Subject: Removal/Deletion – Front/Side Fuel Tank

Models Years Affected: 2020 - beyond

Models Affected: Chevrolet Silverado/GMC Sierra
3500 HD Chassis Cabs with
Diesel Engine (option L5P)

Revision Date: March 25, 2021

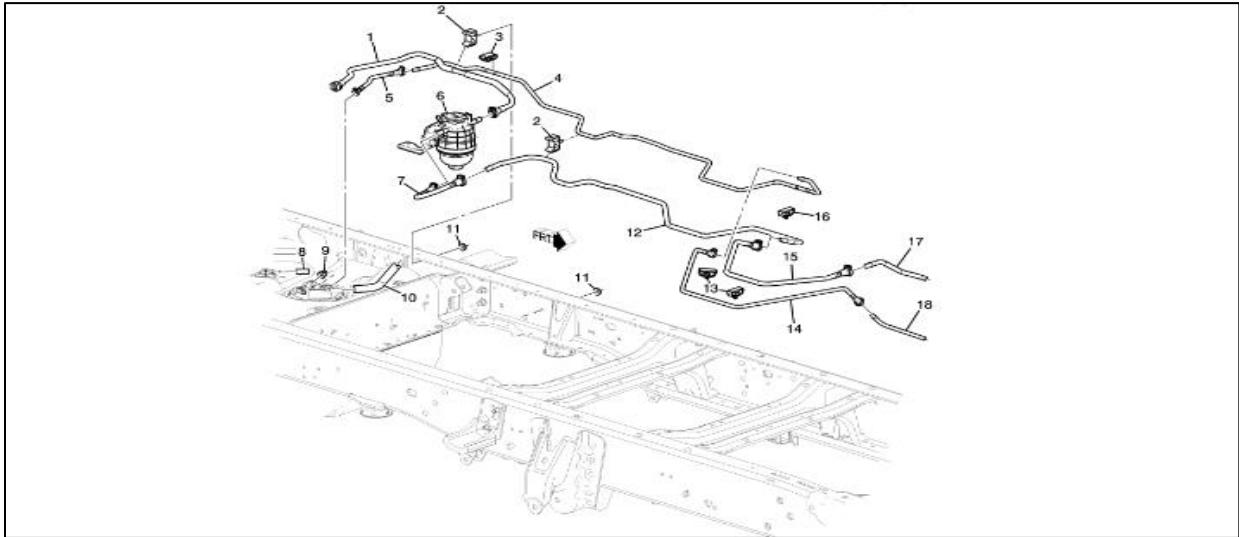
The fuel lines must be reconfigured from dual tank (above) to single rear (below).

Item	Part #	QTY.	Description
			Specific part usage for 310xx (60" CA) 314xx (84" CA) Common Usage for Both models/Cas REUSED
1	84733587	1	HOSE, FUEL/WAT SEP INL (Service Lane Part)
2	15035903	2	CLIP, FUEL FEED & RTN PIPE (NYLON, HOLDS TWO PIPES 12.7/9.5, WIDTH 22, LENGTH 58 W/M8 STUD) (Service Lane Part)
3	22737791	1	CLIP, FUEL FEED & RTN RR HOSE (HOLDS TWO PIPES 12.6/9.5, WIDTH 21, LENGTH 52) (Service Lane Part)
4	84631070	1	PIPE, FUEL RTN RR (AC-Delco #84631070) (Service Lane Part) 310xx (60" CA)
4	84631059	1	PIPE, FUEL RTN RR (AC-Delco #84631059) (Service Lane Part) 314xx (84" CA)
5	84987666*	1	HOSE, FUEL FLTR (Service Lane Part) *replaces P/N 84631060
6		NR	FILTER, FUEL (W/WATSEP) (SEE GROUP 03 "FUEL FILTER & MOUNTING" FOR DETAILED ILLUSTRATED VIEW)
7	84631056	1	HOSE, FUEL FLTR (Service Lane Part)
8	22883445	NR	CAP, F/TNK FIL VENT PIPE (AC-Delco #22883445) (Service Lane Part)
9	23287870	NR	PLUG, F/PMP PORT (AC-Delco #23287870) (Service Lane Part)

10		NR	HOSE, F/TNK FIL VENT (SEE GROUP 03 "FUEL TANK FILLER PIPES & HOSES" FOR DETAILED ILLUSTRATED VIEW)
11	11546459	NR	NUT, FUEL FEED & RTN RR PIPE CLIP (M8X1.25 OD 24, 10THK) (8.915) (Service Lane Part)
12	84733594	1	PIPE, FUEL FEED RR (AC-Delco #84733594) (Service Lane Part) 310xx (60" CA)
12	84733593	1	PIPE, FUEL FEED RR (AC-Delco #84733593) (Service Lane Part) 314xx (84" CA)
13	25792015	3	CLIP, FUEL FEED & RTN PIPE (FOR 905 & 1206 PIPES, 50MMLNG, 15MMWIDTH; W/PSHRTNR) (Service Lane Part)
14	84631064	1	HOSE, FUEL RTN (AC-Delco #84631064) (Service Lane Part)
15	84733586	1	HOSE, FUEL FEED (INCLS CONNECTOR) (AC-Delco #84733586) (Service Lane Part)
16	25792013	1	CLIP, FUEL FEED & RTN PIPE (HOLDS 2 LINES W/MAS-TREE STYLE RETAINER) (Service Lane Part)

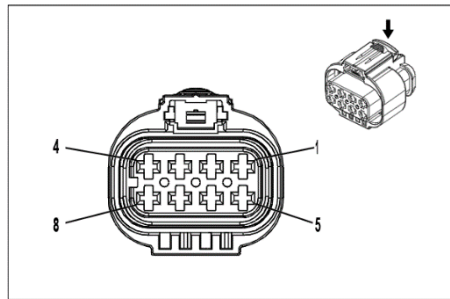
These circuit need to re-routed to the new fuel pump module in the rear tank.

Dual Tank Configuration (N2N)						Single Tank Configuration - Rear Only (N2L)					
Function	Color	Size	Circuit	Pin	From/To	Pin	Circuit	Size	Color	Function	
Fuel Pump Control	GY	2.5	120	2	----->	8	120	2.5	GY	Fuel Pump Control	
Fuel Filter Temperature Sensor Low Reference	BK/VT	0.5	412	24	----->	19	412	0.5	BK/VT	Fuel Filter Temperature Sensor Low Reference	
Run/Crank Ignition 1 Voltage 4	VT/IGN	0.5	439	3	----->	17	439	0.5	VT/IGN	Run/Crank Ignition 1 Voltage 4	
Fuel Filter Temperature Signal	BN/VT	0.5	455	36	----->	4	455	0.5	BN/VT	Fuel Filter Temperature Signal	
Fuel Pump Primary Relay Control	GNG/Y	0.5	465	11	----->	18	465	0.5	GNG/Y	Fuel Pump Primary Relay Control	
Primary Fuel Level Sensor Signal 2	BL/VT	0.8	1589	37	----->	13	1589	0.5	BL/VT	Primary Fuel Level Sensor Signal 2	
Ground 17	BK	2.5	1750	14	----->	22	1750	2.5	BK	Ground 17	
Fuel Pump Supply Voltage Phase 2	YE/GY	2.5	4137	30	----->	9	4137	2.5	YE/GY	Fuel Pump Supply Voltage Phase 2

Fuel Pump Supply Voltage Phase 3	WH/BN	2.5	4138	1	----->	24	4138	2.5	WH/BN	Fuel Pump Supply Voltage Phase 3	
Powertrain Sensor Bus Enable	VT/IGN	0.5	4320	10	----->	16	4320	0.5	VT/IGN	Selective Catalytic Reduction Power Module Wake-Up Signal	
High Speed GMLAN Serial Data [+/-] 7	BL/BN	0.5	4498	7	----->	30	4498	0.5	BL/BN	High Speed GMLAN Serial Data [+/-] 7	
High Speed GMLAN Serial Data [-] 7	WH	0.5	4499	8	----->	15	4499	0.5	WH	High Speed GMLAN Serial Data [-] 7	
Secondary Fused Battery Positive Voltage 53	RD/VT	2.5	5340	46	----->	7	5340	2.5	RD/VT	Secondary Fused Battery Positive Voltage 53	
Fuel Level Sensor Low Reference	BK/GN	0.5	6281	21	----->	28	6281	0.5	BK/GN	Fuel Level Sensor Low Reference	
Water In Fuel Sensor Signal	BL/YE	0.5	6861	16	----->	2	6861	0.5	BL/YE	Water In Fuel Sensor Signal	
Water In Fuel Sensor Voltage Reference	WH/RD	0.5	6862	4	----->	1	6862	0.5	WH/RD	Water In Fuel Sensor Voltage Reference

Water In Fuel Sensor Low Reference	BK/BU	0.5	6863	23	----->	3	6863	0.5	BK/BU	Water In Fuel Sensor Low Reference	
Fuel Pump Assembly Shield Ground	BN	0.8	7444	15	----->	23	7444	0.5	BN	Fuel Pump Assembly Shield Ground	
Fuel Pressure Sensor 5V Reference	BN/RD	0.5	7445	19	----->	12	7445	0.5	BN/RD	Fuel Pressure Sensor 5V Reference	
Fuel Pressure Sensor Signal	BL/WH	0.8	7446	20	----->	26	7446	0.5	BL/WH	Fuel Pressure Sensor Signal	
Fuel Pressure Sensor Low Reference	BK/YE	0.5	7447	35	----->	27	7447	0.5	BK/YE	Fuel Pressure Sensor Low Reference
